DUKE POWER COMPANY
OCONEE NUCLEAR STATION

ATTACHMENT 1

REVISED PAGES

MARK-UP VERSION SHOWING CHANGES

Oconee Nuclear Station
Figure 3.5.2-16c

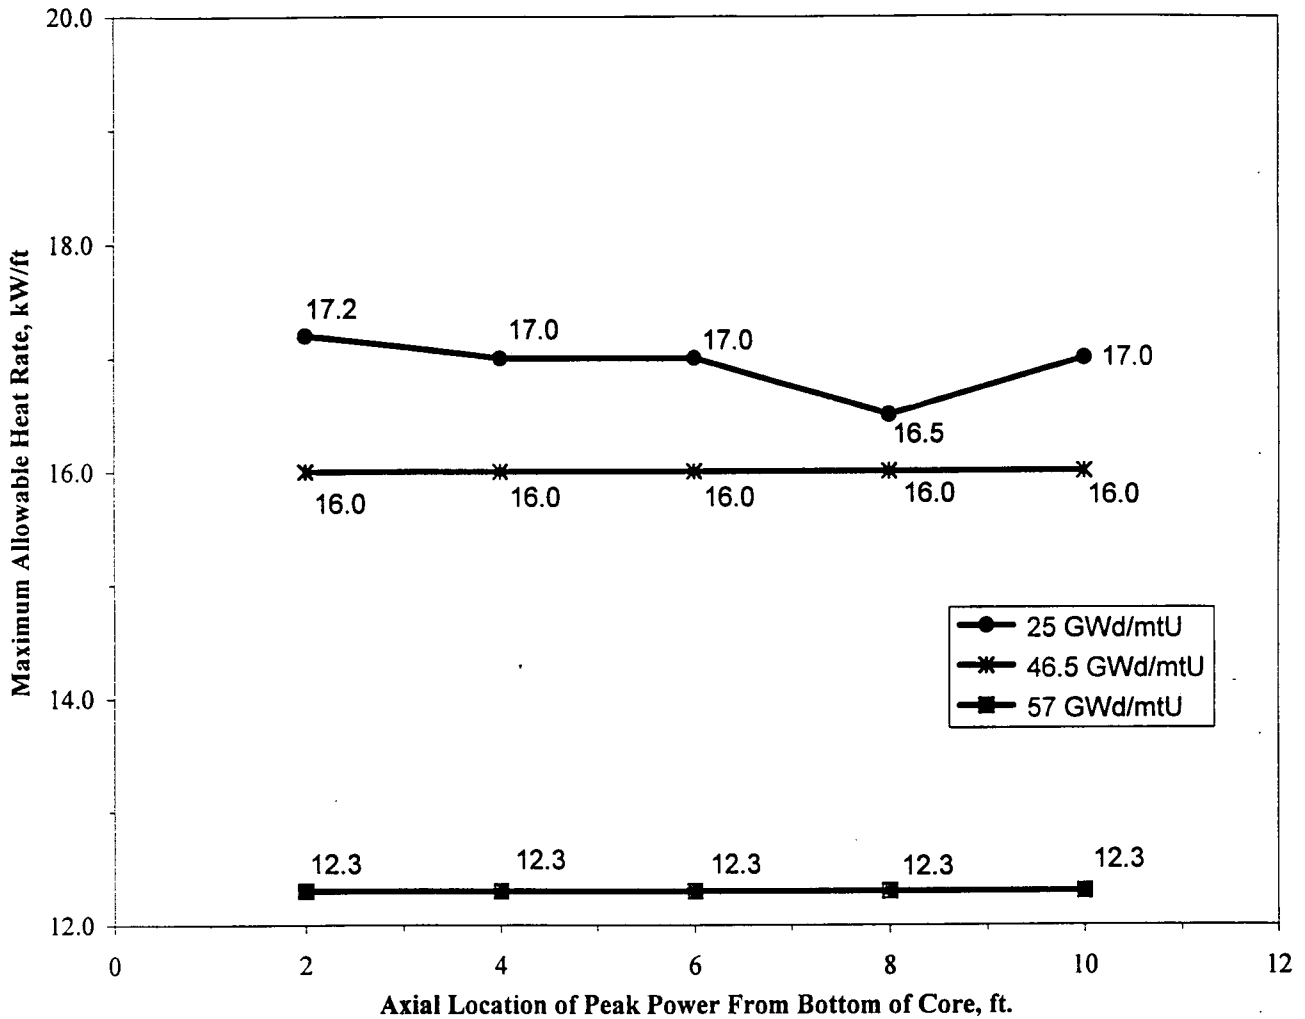
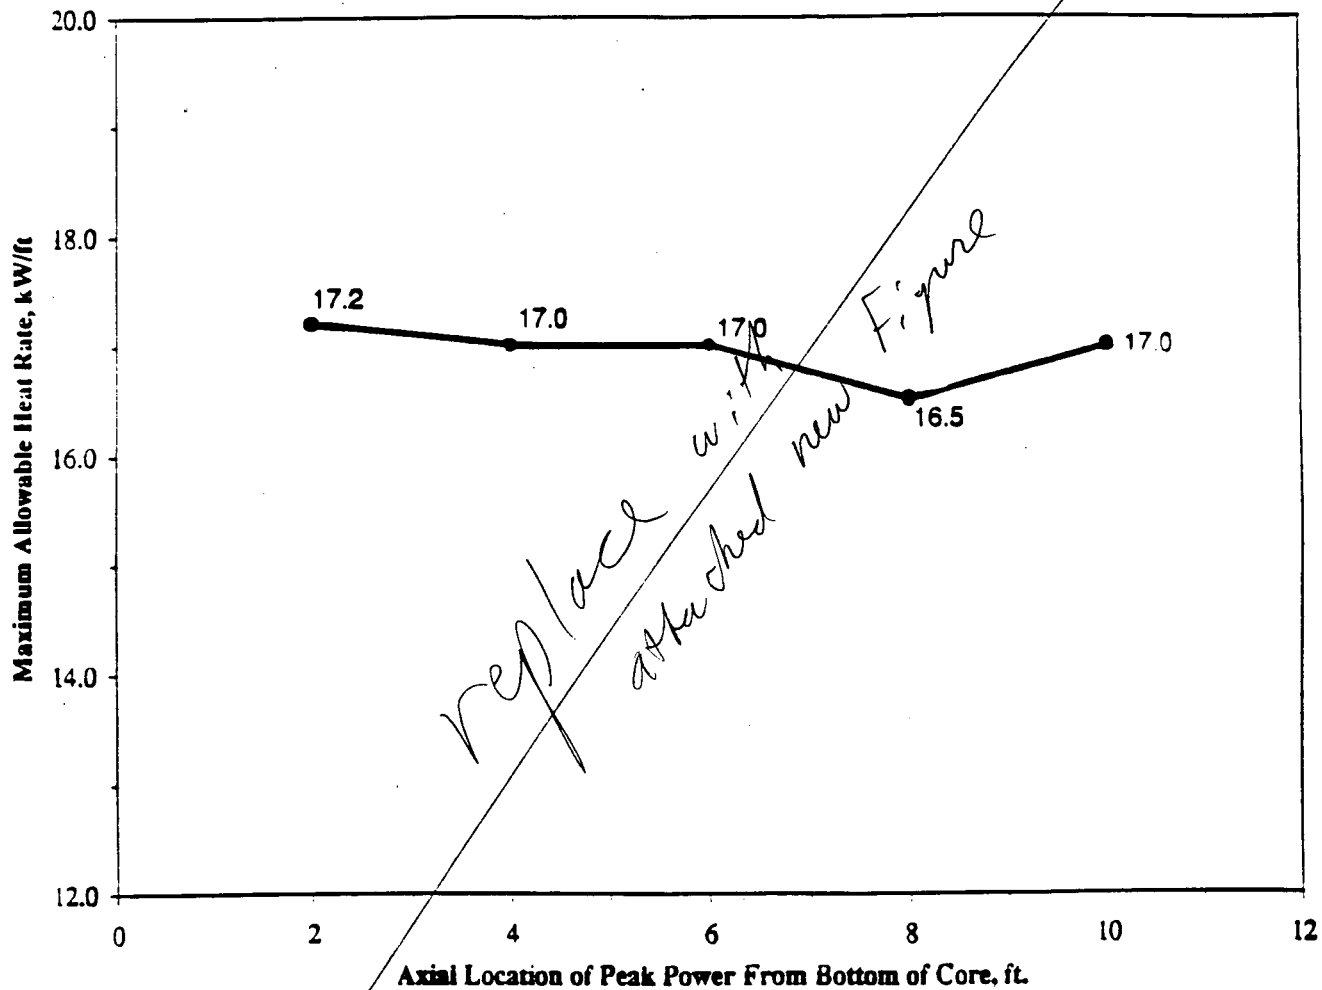
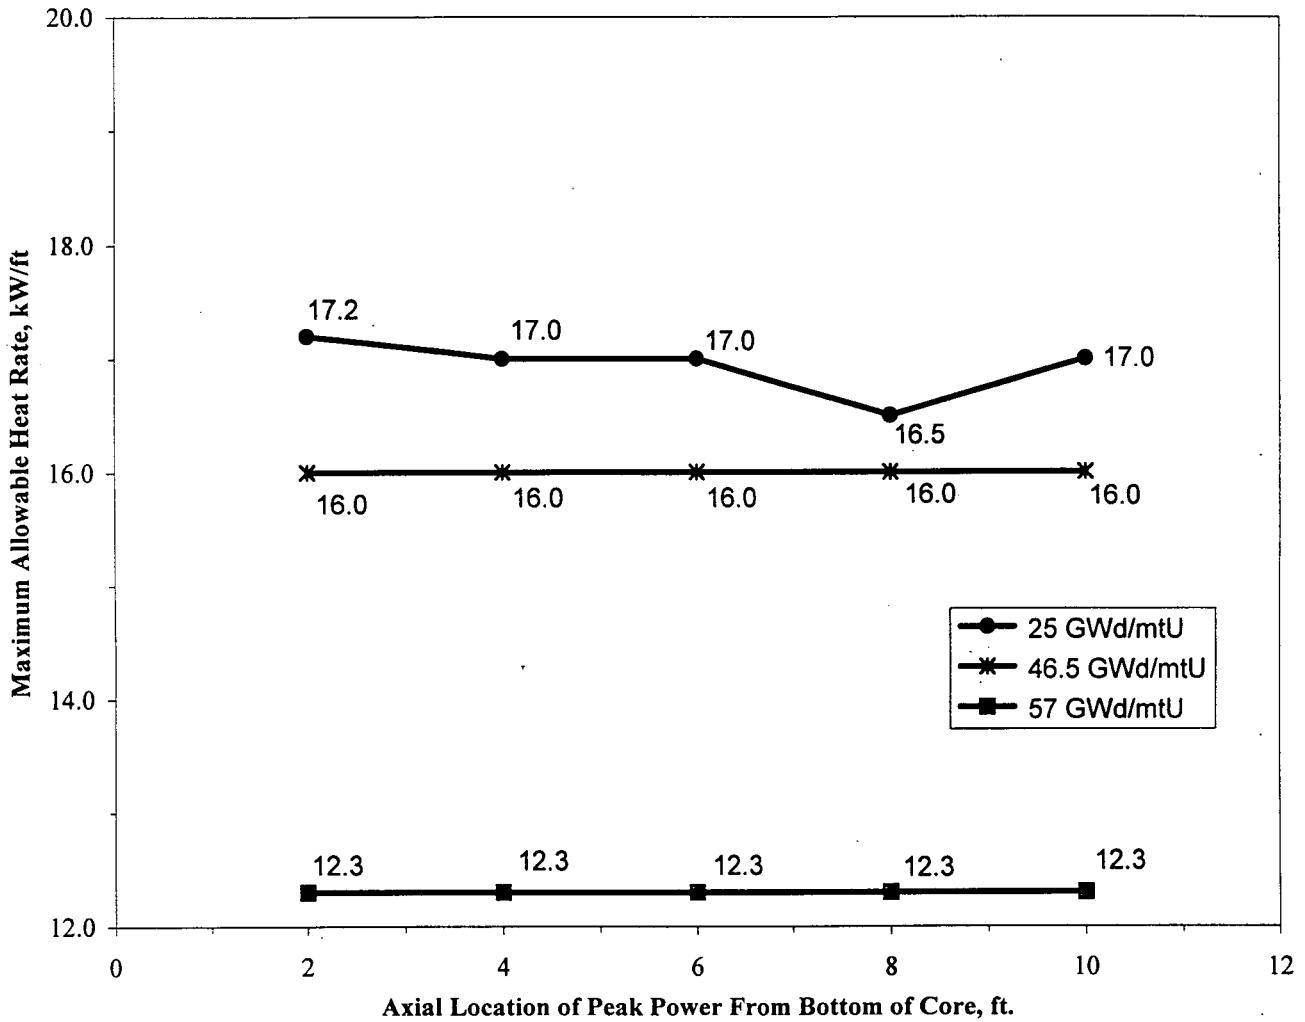
LOCA-Limited Maximum Allowable Linear Heat Rate For Mark-B10⁺ Fuel Rods.
(BOL - 25,000 MWd/mtU)

LOCA-Limited Maximum Allowable Linear Heat Rate For Mark-B10* Fuel Rods
